Work Order ID 96732

Item Name: Crosstube Fwd

DRAWING NO. D407-667-145	TITLE CROSSTUBE ASS'Y (407 HIGH FWD)	REV. C	DART AEROSPACE LTD ENGINEERING ORDER		D.E.O. NO. D407-667-145-C-1	SHEET NO. SHEET 1 OF 1	SCALE NTS
DRAWN 47	CHECKED ASS	MFG. APPR. 188	APPROVED WD		DE APPR. H		
DATE 11.07.15	DATE 11.07.22	DATE 11.07.22	DATE 11/07/22		DATE 11.07.21

DRAWING NO. D407-667-145	TITLE CROSSTUBE ASS'Y (407 HIGH FWD)	REV. C	DART AEROSPACE LTD ENGINEERING ORDER		D.E.O. NO. D407-667-145-C-2	SHEET NO. SHEET 1 OF 1	SCALE NTS
DRAWN AJS	CHECKED	MFG. APPR.	APPROVED		DE APPR.		
DATE 12.08.02	DATE 12.08.02	DATE 12.08.02	DATE 12.08.02		DATE 12.08.02

DETAIL P
BONDING STRAP INSTALLATION 2 PL

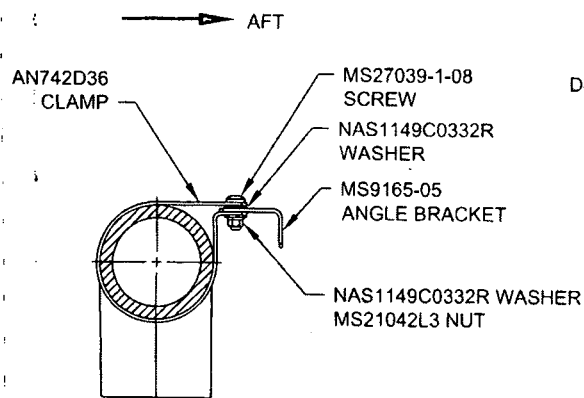
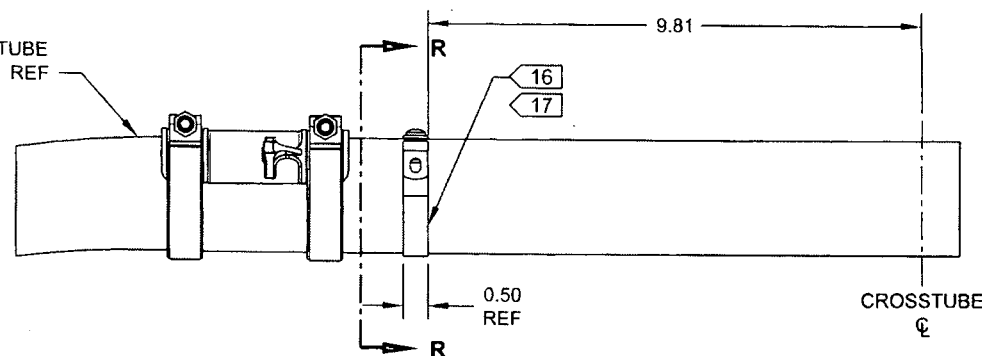
ADD ELECTRICAL GROUNDING STRAP

ITEM	QTY -145	PART NUMBER	DESCRIPTION
1	X	D407-667-145	CROSSTUBE ASSEMBLY (407 HIGH FWD)
⚡			
10	2	AN742D36	CLAMP
11	2	MS9165-05	ANGLE BRACKET
12	2	MS21042L3	NUT (OR MS21042-3)
13	2	MS27039-1-08	SCREW
14	4	NAS1149C0332R	WASHER (OR AN960C10L)
